Re: Turkey Point Units 3 and 4
Docket Nos. 50-250 and 50-251
Editorial Corrections to the 2002 Annual Radiological Environmental Operating Report

SUMMMARY OF EDITORIAL CORRECTIONS to L-2003-112

DISTANT REMP SAMPLING LOCATIONS

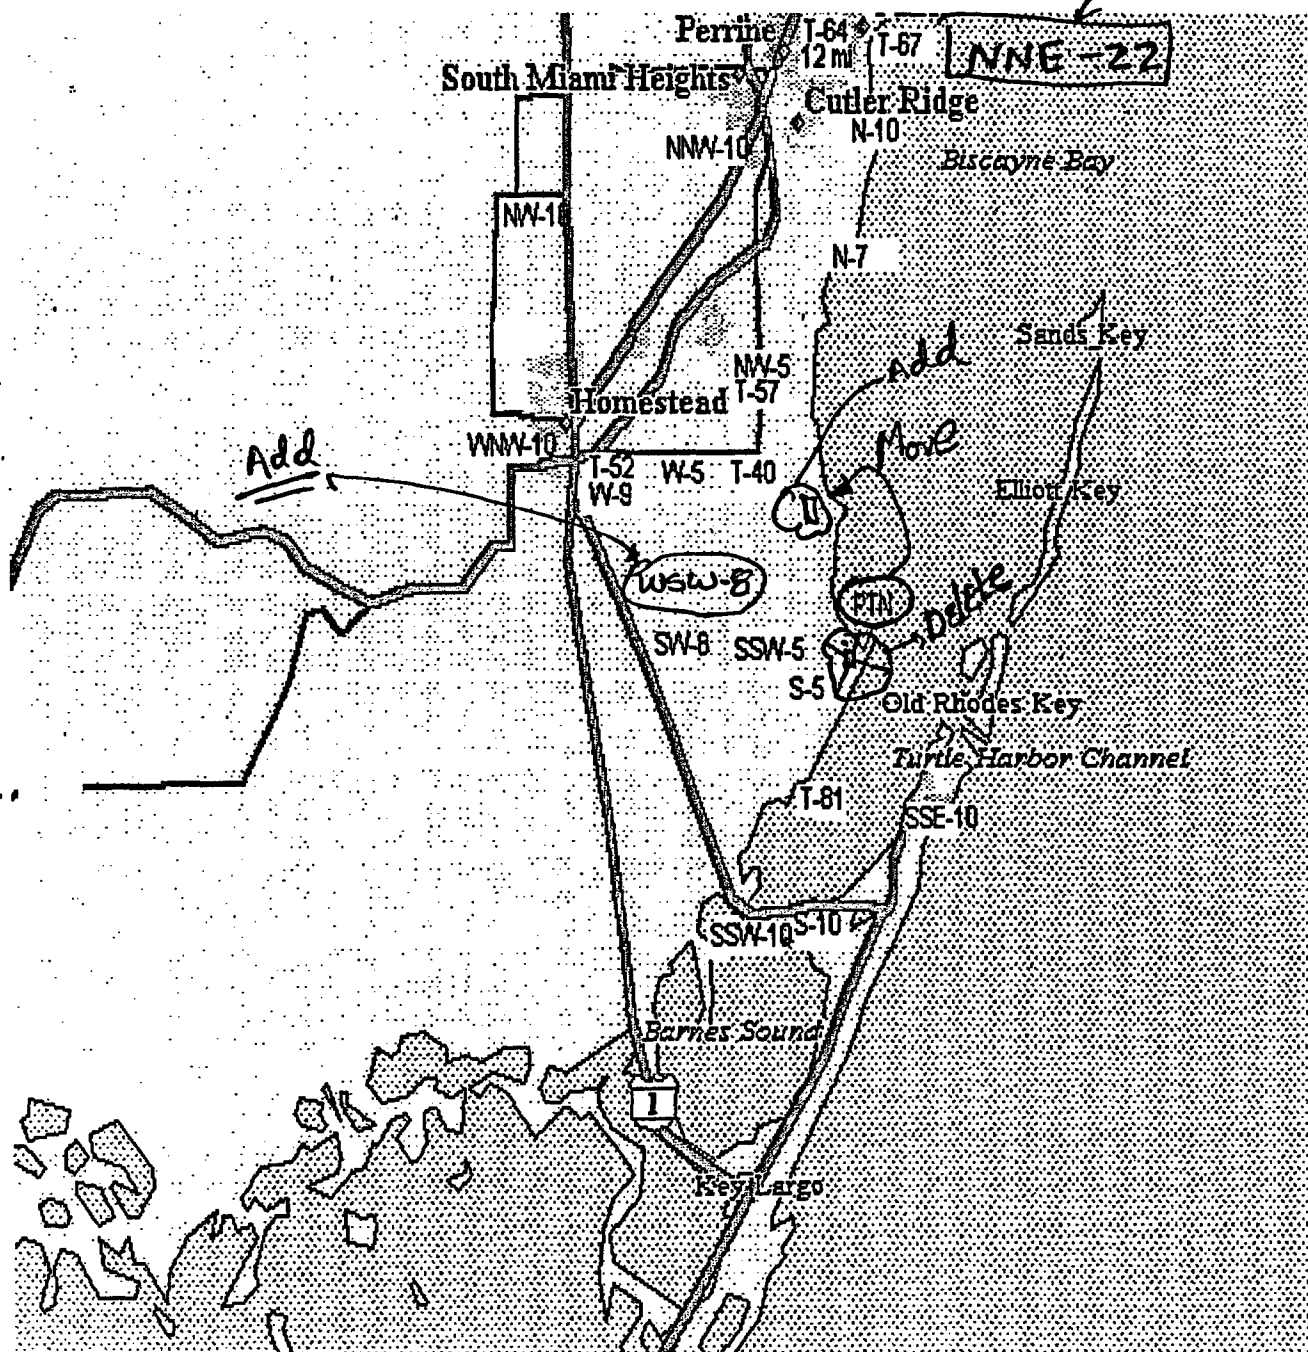
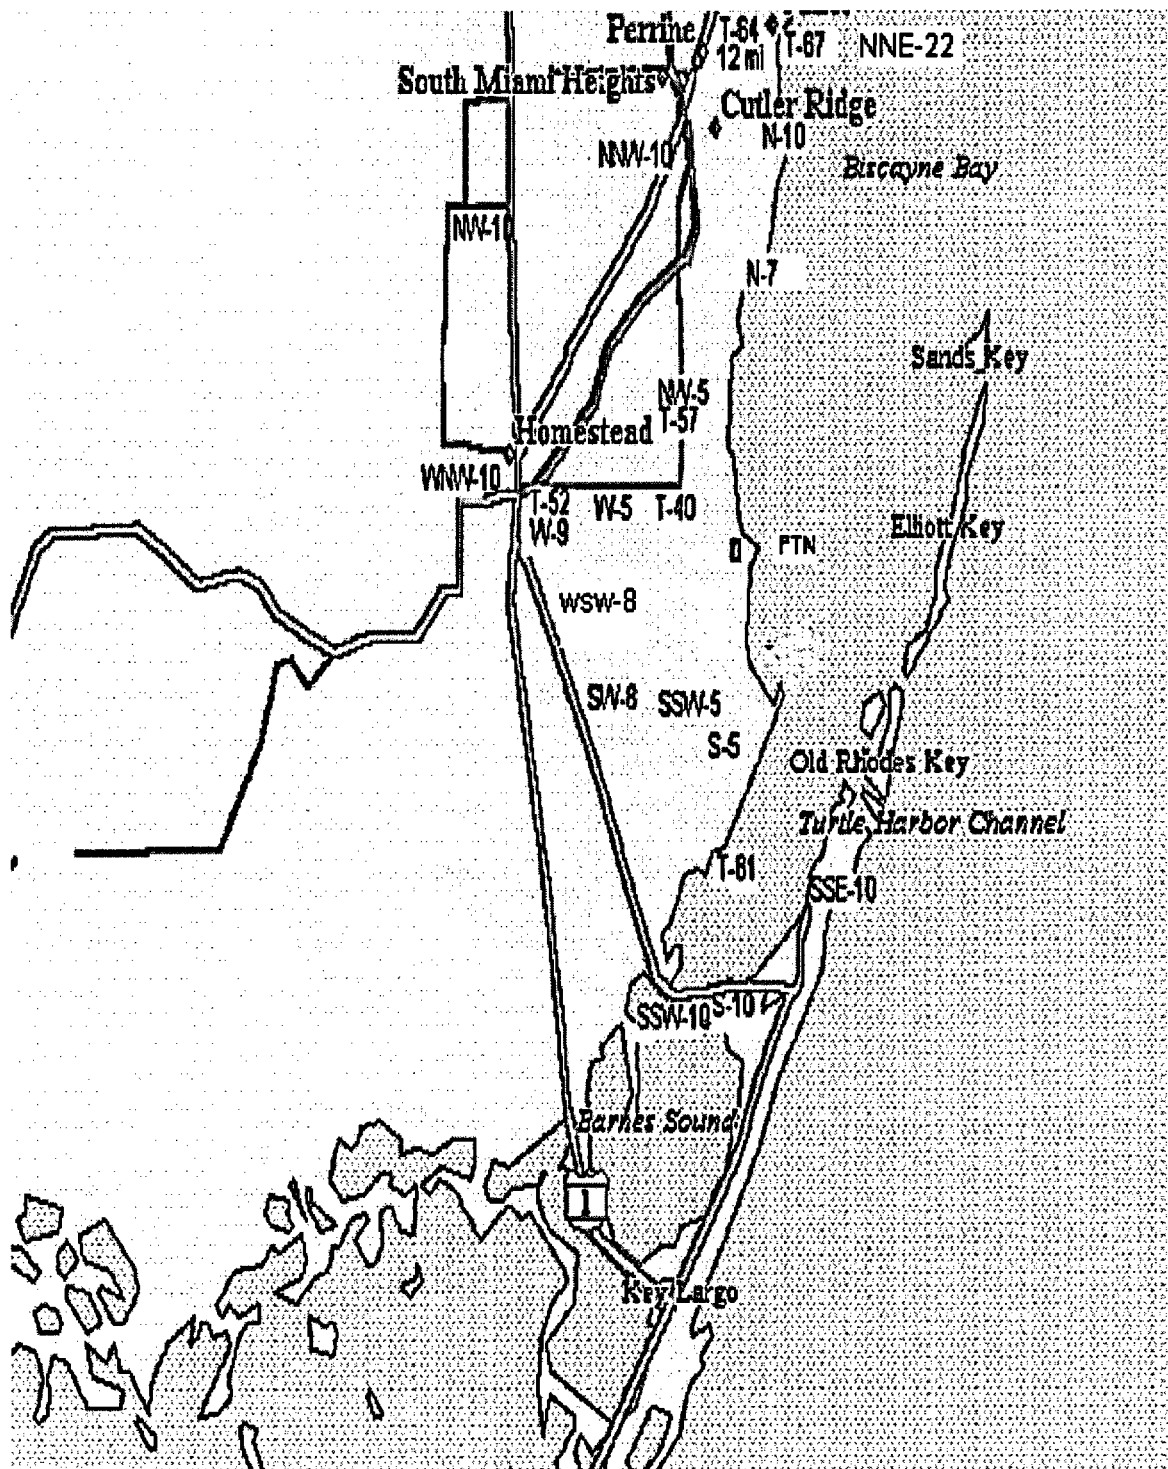
- **TABLE 1, Page 6 of 8:** The correct value for isotope ^{40}K "Control Locations Mean (f)^b Range" is 3068(2/2) instead of 3608(2/2).
- **TABLE 1, Page 7 of 8:** The correct value for isotope ^{40}K "All Indicator Locations Mean (f) Range" is 3722(24/24) instead of 722(24/24).
- **TABLE 1A, Pages 1 of 2 and 2 of 2:** The year of the indicated "Dates" for each Pathway for sections A through D is 02 instead of 03.
- **ATTACHMENT A, KEY TO SAMPLE LOCATIONS:** Distant REMP Sampling Location: This Map was changed to indicate the correct PTN location and to show locations NNE-22, and WSW-8.
- **ATTACHMENT A, KEY TO SAMPLE LOCATIONS:** The address for Natoma Substation is added in Page 1 of 4.
